27 March 2007

Mr. Robert B. Tierney
Chair
NYC Landmarks Preservation Commission
1 Centre Street
New York, NY 10007

Re: **New-York Historical Society**

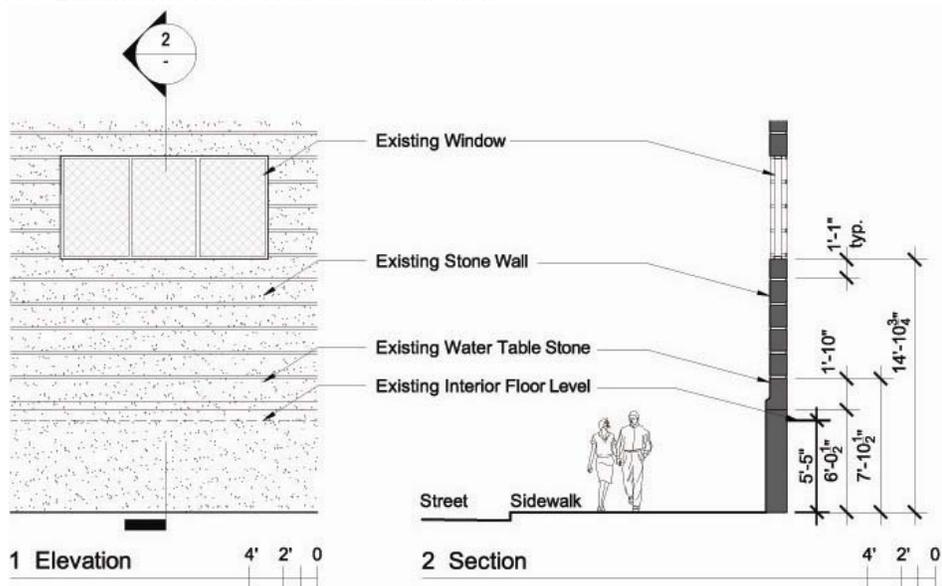
3. **Site lines**

Much has been made of the desire to 'open up' the façades to make the building more inviting, including larger windows so that people can see in to the exhibits and the activity within. The building dimensions are such that even if the façades were allowed to be 'opened up', the results would be as follows:

Central Park West

From the sidewalk level to the top of the 'water table stone' (that is, the curved stone on top of the flat base wall) the total height is as follows:

- | | |

| a. base wall | 5'-0½" |
| b. water table stone | 1'-10" |
| Total | 6'-10½" (please refer to photos below & diagram following) |

West 77th Street

From the sidewalk level to the top of the 'water table stone' (that is, the curved stone on top of the flat base wall) the total height is as follows:

- | | |

| a. base wall | 6'-0½" |
| b. water table stone | 1'-10" |
| Total | 7'-10½" (please refer to photos below & diagram following) |

The dimension in a man from the center of his eyes to the top of his head varies between 4½" to 5". For a woman, it can vary between 3½" to 4". Hence, in a 6'-0" man, his eyes would be approximately 5"-7" above the ground, or 2'-3" below the water table stone. He would be unable to see into the building, the exhibits and the people meandering about. He would see only the ceiling. This, of course, would be even totally impossible for a woman or a child. The tallest basketball player in the world could not accomplish what the director has stated publicly as an objective.
